Access Compliance Report

Public Rights-of-Way

(Curb Ramps)

Intersection ID: 27895	Main Street: FAIR_ISLE_DR	Cross Street: KILCHURN_CT	Location:	N
ADA ID: 42896DE8C3E3	Ramp Type: Perp	Initial Pass/Fail: Fail	Overall Compliance: No	Severity Score: 13.75

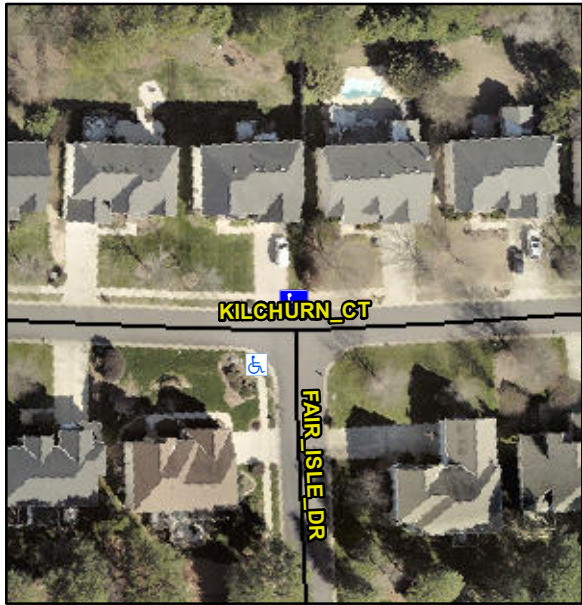
Codes/Mitigation Info/Possible Solution			Field Measurements/Component Compliance							
	Possible Solutions:		Compliance			Description			Data	
	Remove & Replace Entire Ramp.		N/A	Ramp Length (in)	50.0	No	Ramp Slope (%)	11.6		
			Yes	Ramp Width (in)	48.0	No	Ramp XSlope (%)	4.9		
			N/A	Flare Type LT	N/A	N/A	Flare Type RT	N/A		
			N/A	Flare Slope LT (%)	N/A	N/A	Flare Slope RT (%)	N/A		
			N/A	Flare Traversable LT?	N/A	N/A	Flare Traversable RT?	N/A		
			N/A	Landing Length (in)	N/A	N/A	DWS Provided?	N/A		
			N/A	Landing Width (in)	N/A	N/A	DWS Contrast?	N/A		
			N/A	Landing Slope (%)	N/A	N/A	DWS Length (in)	N/A		
			N/A	Landing X Slope (%)	N/A	N/A	DWS Full Width?	N/A		
Surveyor Notes:		N/A	N/A	Landing Curb? (Y/N)	N/A	N/A	DWS Offset (in)	N/A		
PROW/ADA:		Not Found, R304.2.2, R304.5.3	N/A	Shared Landing?	N/A					
			N/A	Gutter Ponding?	N/A	N/A	Gutter Slope (%)	N/A		
			N/A	Gutter Lip Ht (in)	N/A	N/A	Gutter X Slope (%)	N/A

N/A	Painted X Walk1?	No	N/A	Painted X Walk2?	N/A		
				X Walk 1 Direction	To SW		X Walk 2 Direction	N/A		
			N/A	X Walk 1 Width (in)	N/A	N/A	X Walk 2 Width (in)	N/A		
				X Walk 1 Slope (%)	3.7		X Walk 2 Slope (%)	N/A		
				X Walk 1 X Slope (%)	4.4		X Walk 2 X Slope (%)	N/A		
			N/A	Ramp inside XWalk1?	N/A	N/A	Ramp inside XWalk2?	N/A		
				Road Slope (%)	N/A	N/A	Clear Space?	N/A		
				Road X Slope (%)	N/A	N/A	Clear Space to XWalk (in)	N/A		
			N/A	Any Obstructions?	N/A	N/A	Storm Grate/Utility Hazard?	N/A		
				Obstruction Type			Storm Grate/Utility Type			
					N/A			N/A		
						Yes	Surface Condition? (G/P)	Good		
Street 1 Name		KILCHURN CT								
Stop Condition-Street 2		None								
Street 2 Name		N/A								
Stop Condition-Street 1		N/A								
Total Cost:		\$ 1850.00
